Reference: JST Accessibility Review – Access Report  
Development Application

Project: Sydney Opera House  
Joan Sutherland Theatre Accessibility Projects

Document Type: Access Report – Development Application

Report Number: IAC-333

Figure 1 Wheelchair Seating positions within the stalls of the Joan Sutherland Theatre (49-VA-SC021\_DA182\_A)

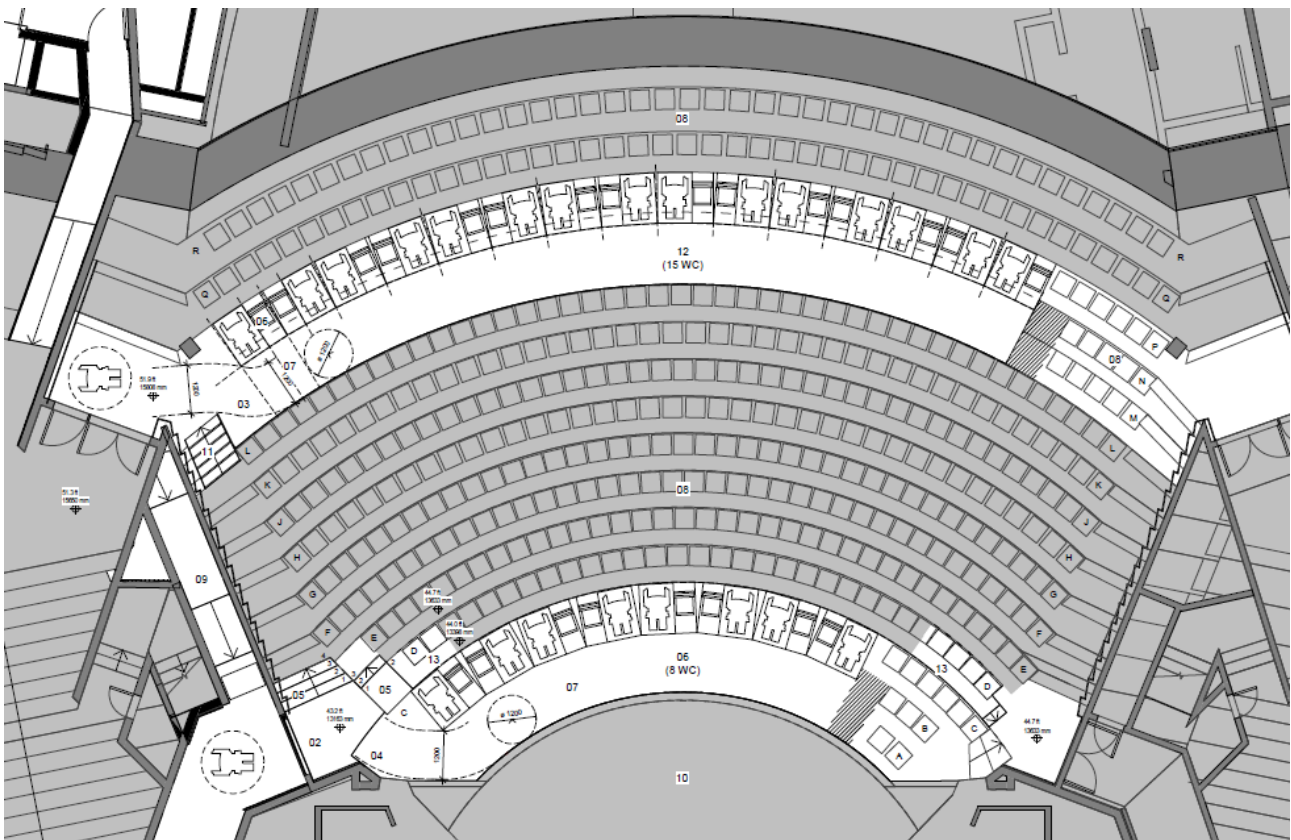
The seating rows within the Joan Sutherland Theatre affected by the works are Stalls Rows A-C and M-P. In this proposal 8 wheelchair seating locations are proposed at Stalls Rows A-C and 15 wheelchair seating locations at Stalls Rows M-P. No wheelchair accessible seating is proposed for the Loge or Circle sections of the theatre.

In this proposal it is proposed to provide the wheelchair seating on demand by the removal of fixed seating.

Figure 2 Allocation of seating by cost of ticket.

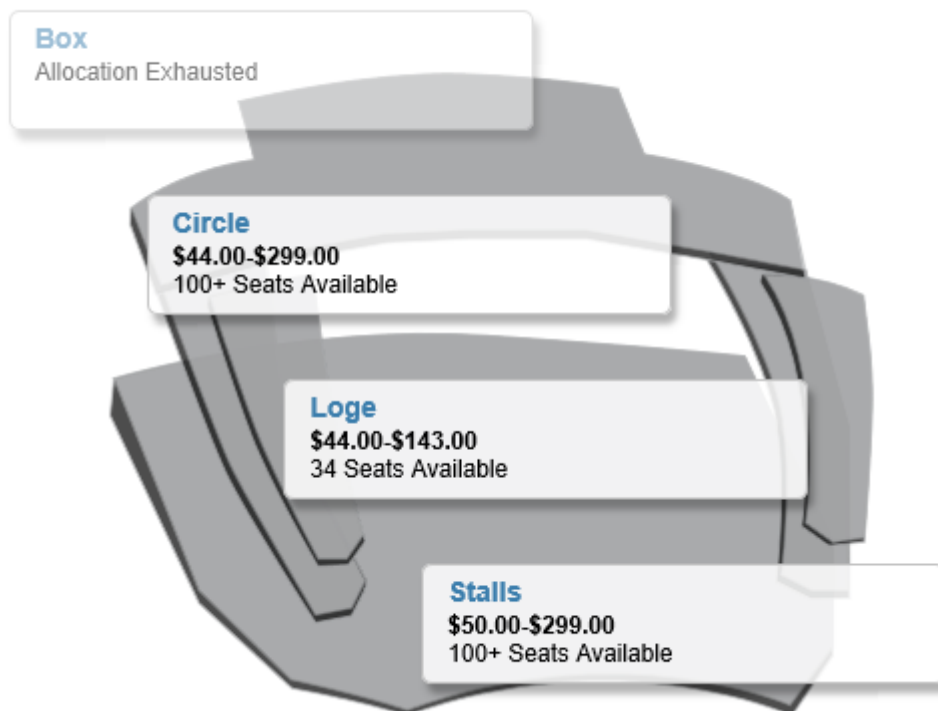
Compliance with Table D3.9 requires that the wheelchair seating provided be representative of a range of seating available. Within the Joan Sutherland Theatre, the range of seating is identified by the prices charged. The plan following illustrates the allocation of seating types by cost of ticket within the Joan Sutherland Theatre.

The spatial arrangements and grouping proposed for the wheelchair seating spaces satisfy the provision of NCC Table D3.9 and Clause 18 of AS1428.1:2009.

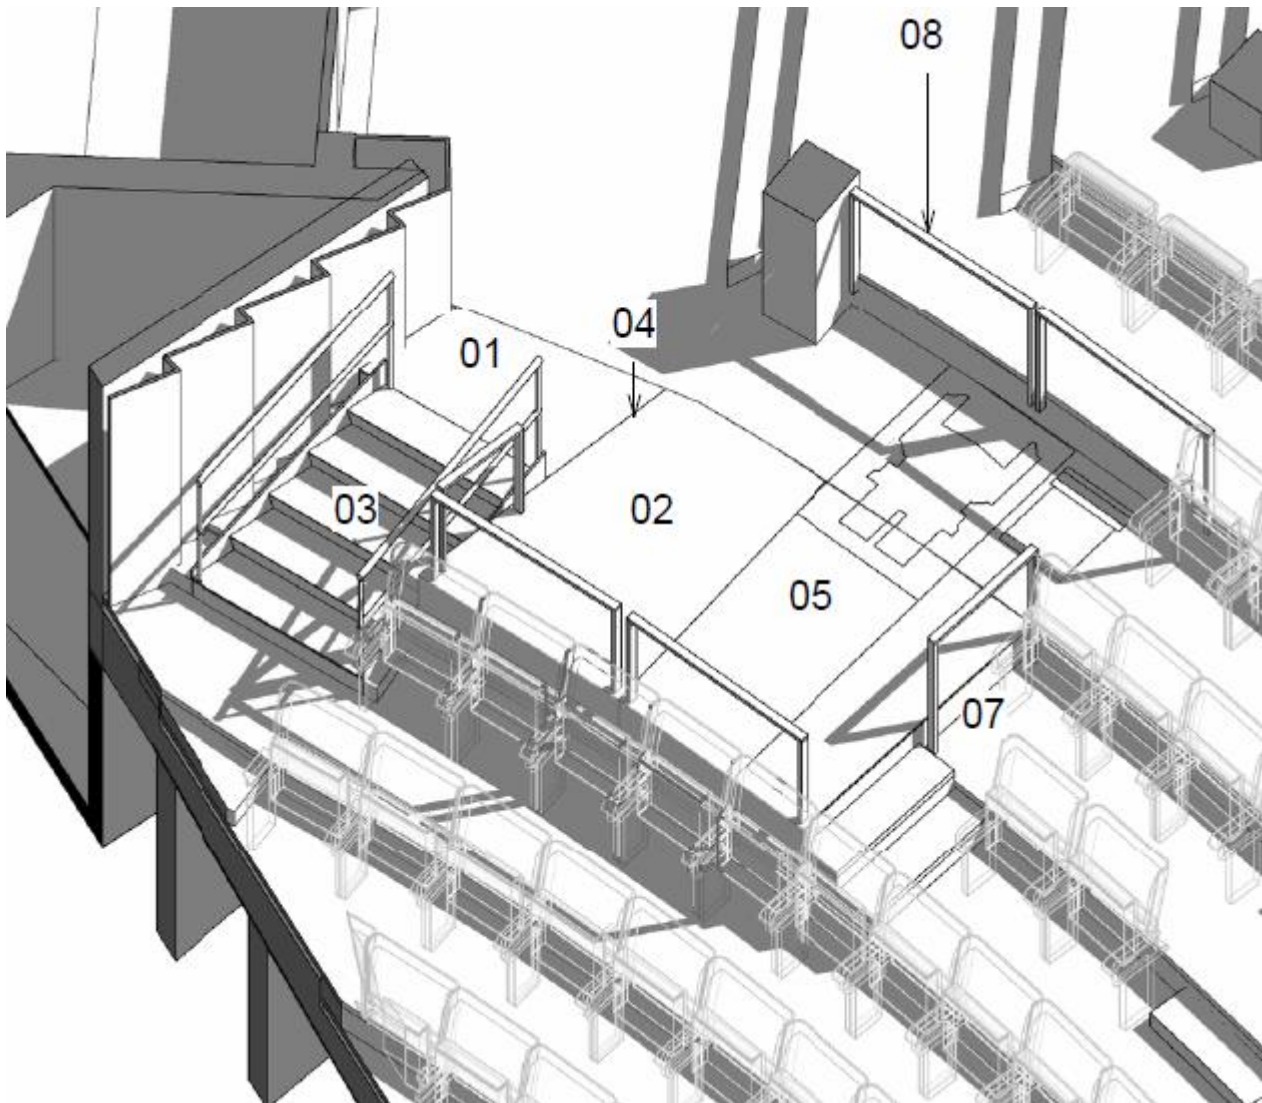
The proposal identifies buildability issues. The provision of wheelchair accessible seating in the locations nominated is reliant on personnel configuring the seating for every performance. It will be essential that a checklist be developed to be signed off. As the design relies on the inserting of platforms it will be essential to ensure that the junctions of materials satisfy the tolerances between finishes identified at section 7 of AS1428.1:2009.

*Abutment of surfaces shall have a smooth transition. Design transition shall be 0 mm.  
Construction tolerances shall be as follows:*

- (a) *0 ±3 mm vertical*
- (b) *0 ±5 mm, provided the edges have a bevelled or rounded edge to reduce the likelihood of tripping*

Level 3 – Lift 8 – Western Tunnel interface

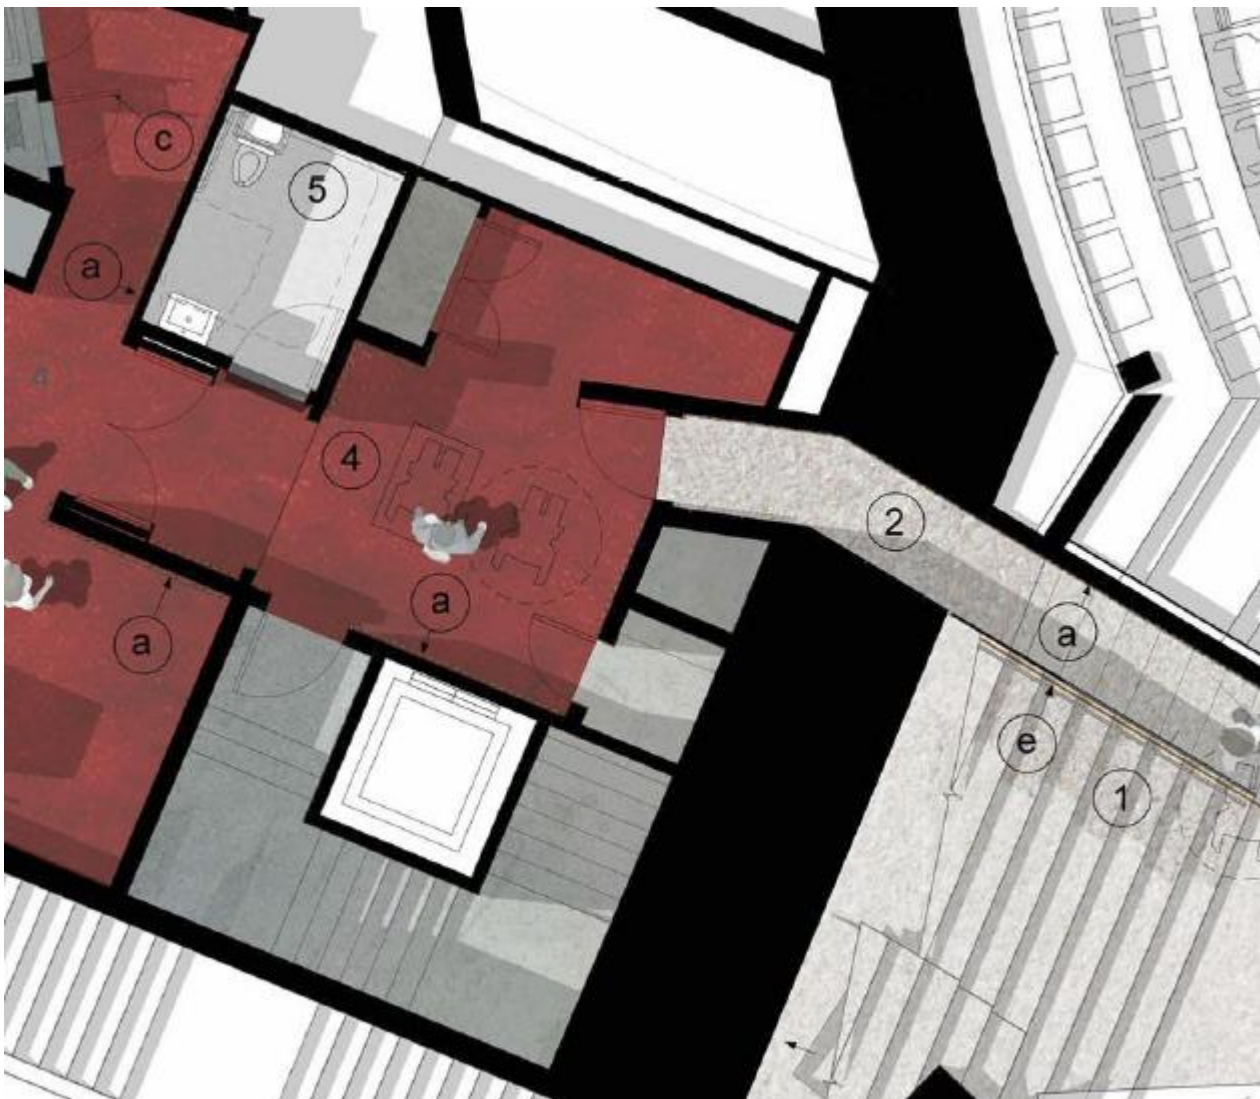
The proposed works relate to the modification of the walls that separate the Lift 8 lobby from the fire stairs that wrap around Lift 8 and the proposed fitout of the new public lobby. It is proposed to extend the Northern Foyer finishes into these new public lobbies.

The interface of differing floor finishes will need to satisfy the provisions of Clause 7 of AS1428.1:2009. It may be necessary to feather the floor finishes to satisfy these requirements and provided a step free transition between finishes.

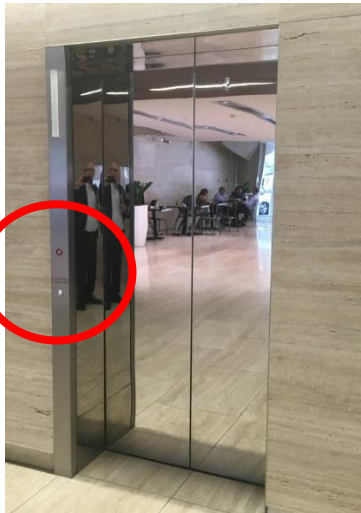
The minimum lift car dimension to satisfy the requirements of NCC Part E is 1100 x 1400 mm.

Figure 5 Extract from plan indicating Level 2 passage connection to Northern Foyer (49-VA-SC021\_DA130\_A)

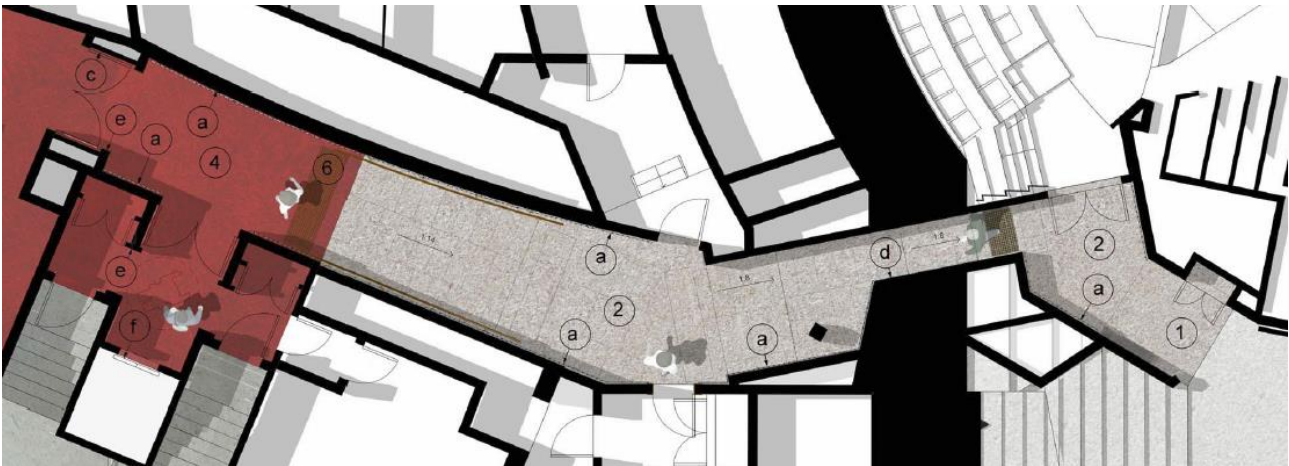
The new western tunnel connecting the southern and northern foyers at level 2 incorporates a 1:14 ramp at the northern end of the tunnel and two 1:8 ramps separated by a 2.4m mid landing to the southern side of the tunnel.

The passage varies in width along its length. A passing zone is provided at the landing between the 1:14 and 1:8 ramps.

The tunnel narrows to 1010mm at the southern end where the tunnel passes through a major structural element of the building.

The width between any handrails along the 1:14 ramp section is to be a minimum of 1m clear.

The 1:8 ramp sections will incorporate a single handrail located along the eastern side of the tunnel. Where the tunnel passes through the main structural element of the building the clear width of the aisle way will be less than the required 1m (approx.920mm). A performance Statement has been prepared to address this site condition.

The operation of the doors is by way of a door assist device which will open both doors simultaneously. The specific detail of the operation of the doors has yet to be finalised.

The detailing of these ramps will need to satisfy the requirements of Clause 10.3 of AS1428.1:2009 as far as handrail and handrail extension design, the installation of TGSIs at the top and bottom of each ramp and the provision of a non-slip floor surface achieving a slip resistance of P3 / R10 in accordance with NCC Table D2.14.

Suitable wayfinding and signage will need to be provided.

Figure 6 Extract from plan indicating Level 3 passage connection to Northern Foyer (49-VA-SC021\_DA240\_A)

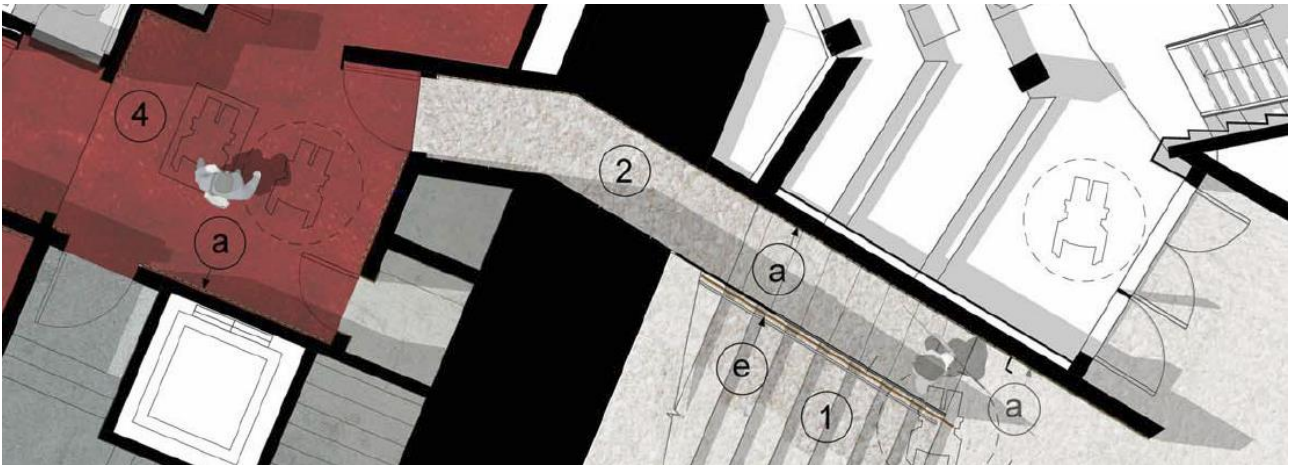
The passage has a minimum width of 1m and is not straight. It is recommended that a mirror be installed at the change in direction so as to provide assistance to patrons negotiating this passage at this level.

The width of the door along this passage will need to be a minimum of 850mm clear. The door will be operated by a door assist device due to the absence of latchside clearance at the door.

Suitable wayfinding and signage will need to be provided.

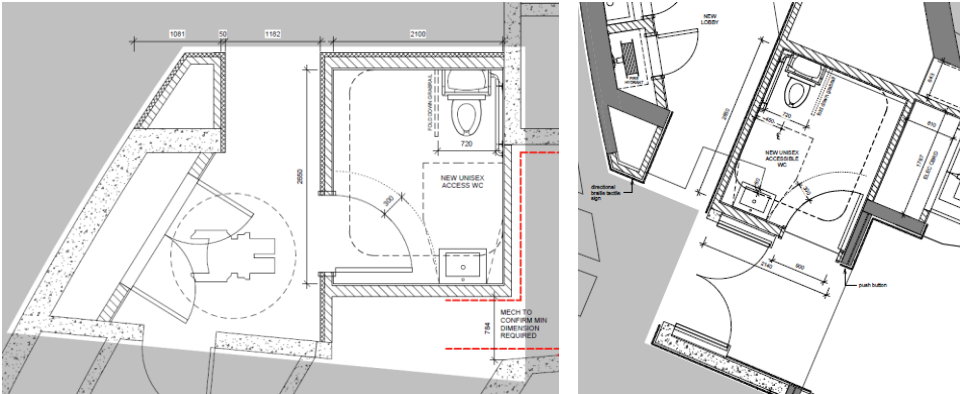
The approach adopted to satisfy the requirements of NCC Clause F2.4 concerning the provision of ambulant WC facilities has been to incorporate a fold down grabrail within the accessible WC

facilities located at this level. A performance statement will need to be prepared to address this approach.
